## S E R V I C E N O T E

**8751A Network Analyzer**

**Modification to fix unexptected spurious problem.****To Be Performed By:** Agilent-Qualified Personnel**Parts Required:**

Figure 1. A3 Board Modification

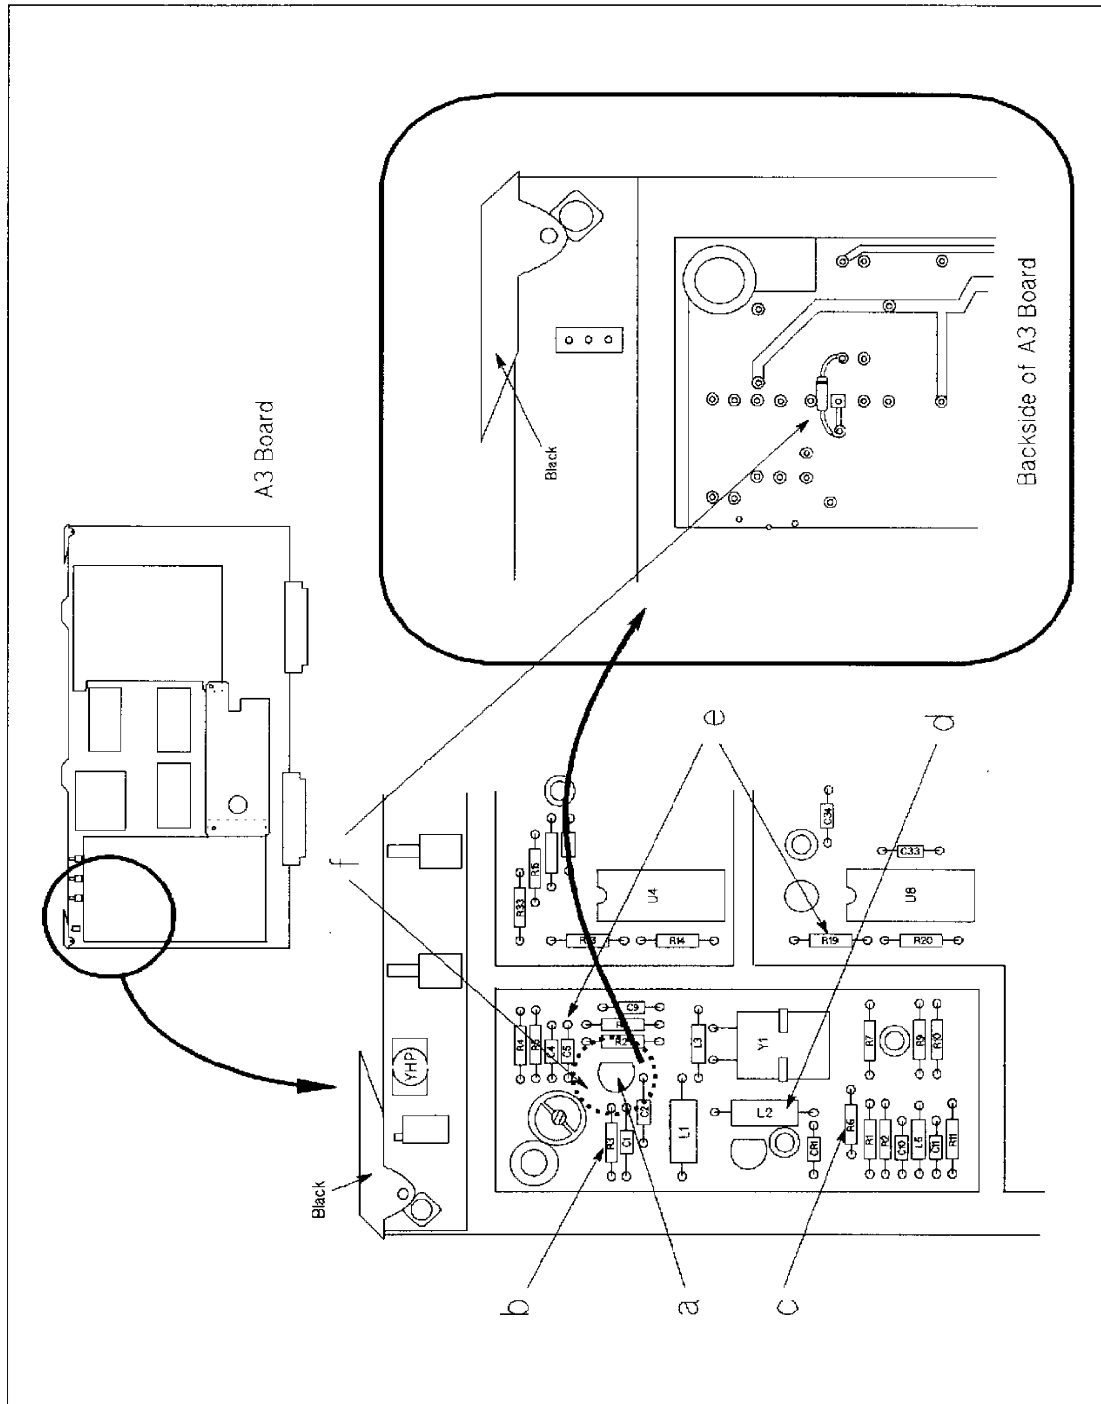
The 8751A may show the unexpected spurious response due to the parasitic oscillation of the source signal.

This is caused by the breakdown of A3Q2 transistor. This symptom can be confirmed using the following procedures:

1. Turn the 8751A off. Remove the top cover and the shield plate.
2. Remove the A3 board.
3. Modify the A3 board with referring Figure 1:
  - a. Replace the A3Q2 transistor (P/N 1854-1073) with the new one.
  - b. Replace the R3 resistor. 464 ohm --> 1 kohm (P/N 0757-0280)
  - c. Replace the R6 resistor. 464 ohm --> 316 ohm (P/N 0698-3444)
  - d. Replace the L2 inductor. 680 nH --> 470 nH (P/N 9100-3548)
  - e. Replace the location of C5 (0.01 uF, P/N 0160-4832) and R19 (215 ohm, P/N 0698-3441).
  - f. Add the diode (P/N 1901-0050) with referring Figure 1.
4. Perform the following adjustments:  
100 MHz VCXO Frequency  
Fractional N Osc Spurious  
1st IF Offset Osc Frequency  
LF power linearity
5. Reinstall the A3 board.
